COUNCIL ASSESSMENT REPORT

Panel Reference	PPSSNH-526
DA Number	DA-2024/159
LGA	Willoughby City Council
Proposed Development	Amendment to an approved development construction of 5 residential flat buildings comprising a total of 180 units (154 units previously approved) over basement car parking, landscaping, road widening, new footpath and street planting.
Street Address	1 Walter Street WILLOUGHBY NSW 2068
Applicant/Owner	Applicant: Mo Chehelnabi (Architecture Urbaneia) Owners: Walter Projects Pty Ltd
Date of DA lodgement	25/07/2024
Number of Submissions	Ninety-two (92) submitters
Recommendation	Consent subject to conditions
Regional Development Criteria (Schedule 6 of the SEPP (Planning Systems) 2021	Estimated development cost over \$5 million that relates to affordable housing
List of all relevant s4.15(1)(a) matters	<ul style="list-style-type: none"> • Environmental Planning & Assessment Act 1979 • Environmental Planning & Assessment Regulation 2021 • State Environmental Planning Policy (Housing) 2021 • State Environmental Planning Policy (Planning Systems) 2021 • State Environmental Planning Policy (Transport and Infrastructure) 2021 • State Environmental Planning Policy (Biod

The WDCP Part B 7.6.1 Figure 5 indicative building envelope shows the following:

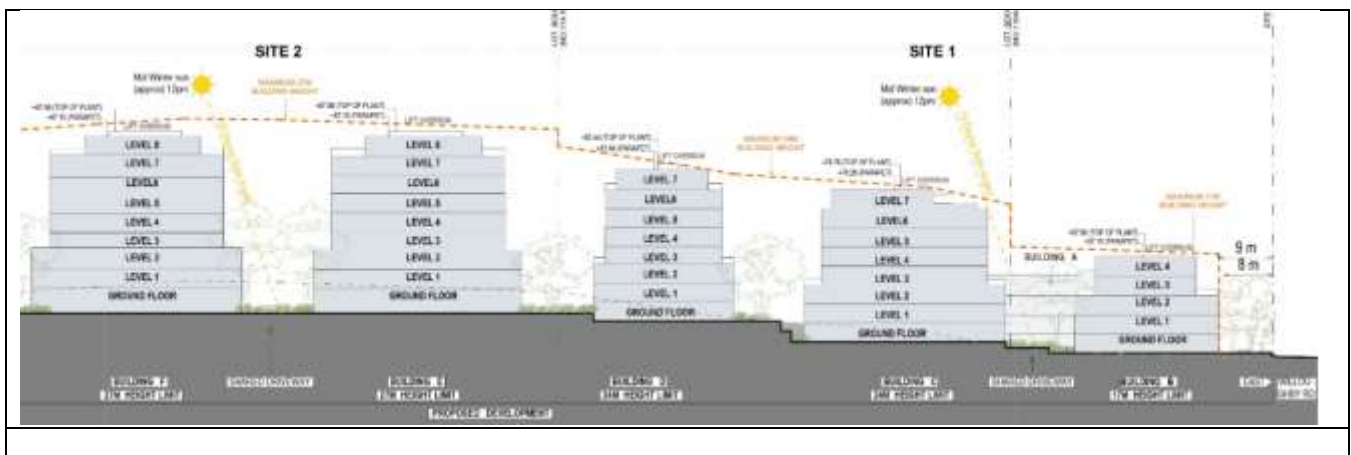
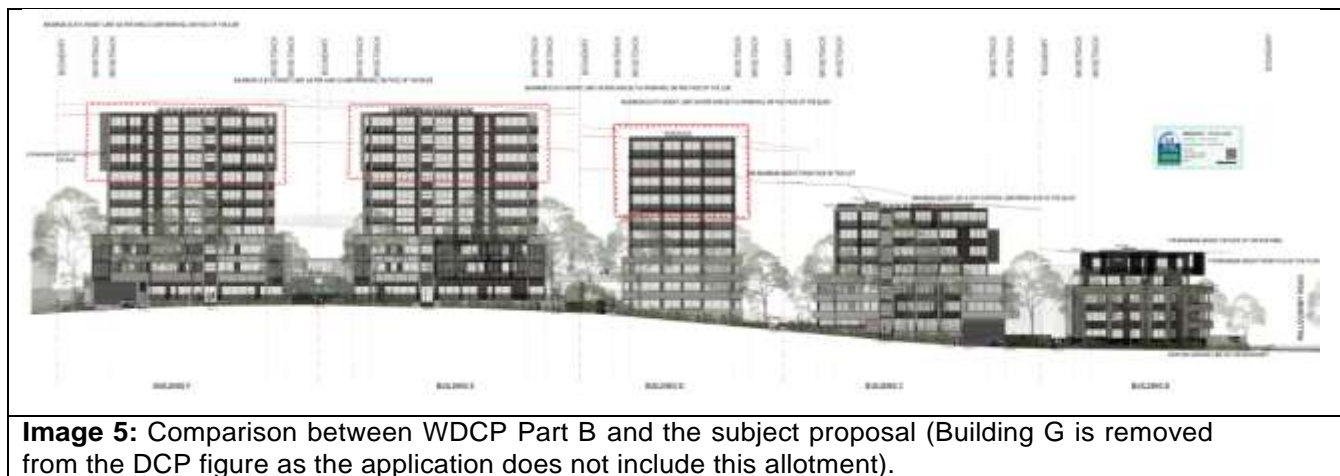
The applicant states that the additional floors within Building D, E and F while increasing the building height and built form, are in generally accordance with the approved Planning Proposal and meets the objectives of the Housing SEPP and planning vision for the area. The applicant says the proposal's new transition from 5-storey form on the corner of Willoughby Road and Walter Street, then 10-11 storeys on Walter Street is in keeping with the original approved transition of additional height as the viewer moves along Walter Street.

Council assessment officer response

Image 9: Departure at Building F

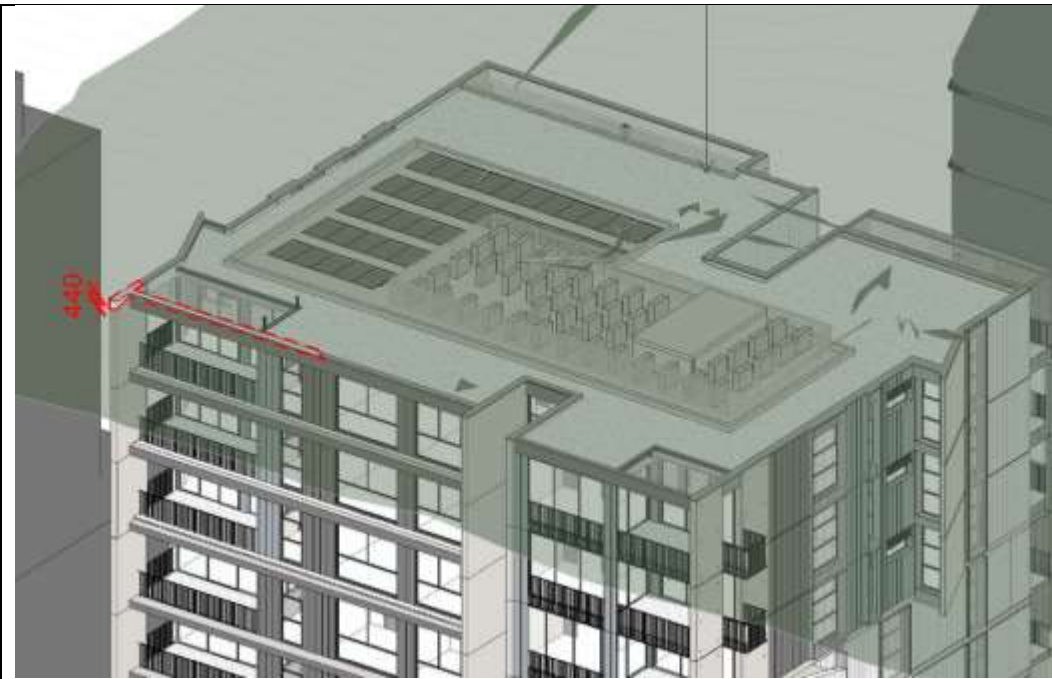
The views impacts are considered reasonable following an assessment pursuant to Tenacity. The extent of variation (in practical terms) - see areas shown below, do not themselves create a detrimental impact on views.

Image 10: Departure at Building D

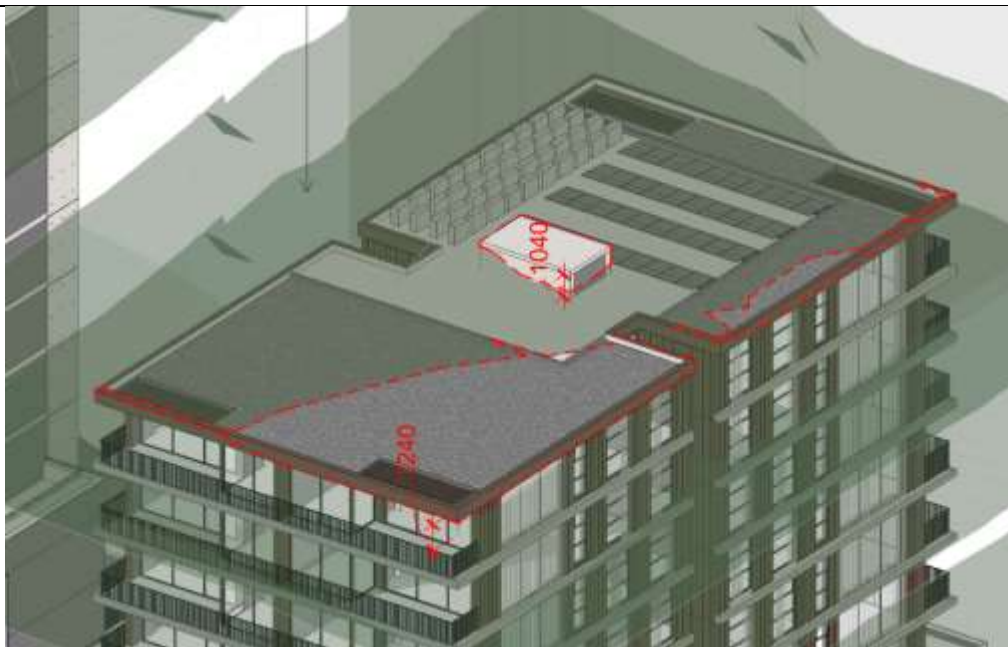
Privacy is attained by spatial separation. Building F is separated from the rear boundary by 21.6m and 23m where the ADG seeks (for 9+ storeys) 12m. Building E is separated from the rear boundary by 23.2m and 21.7m.
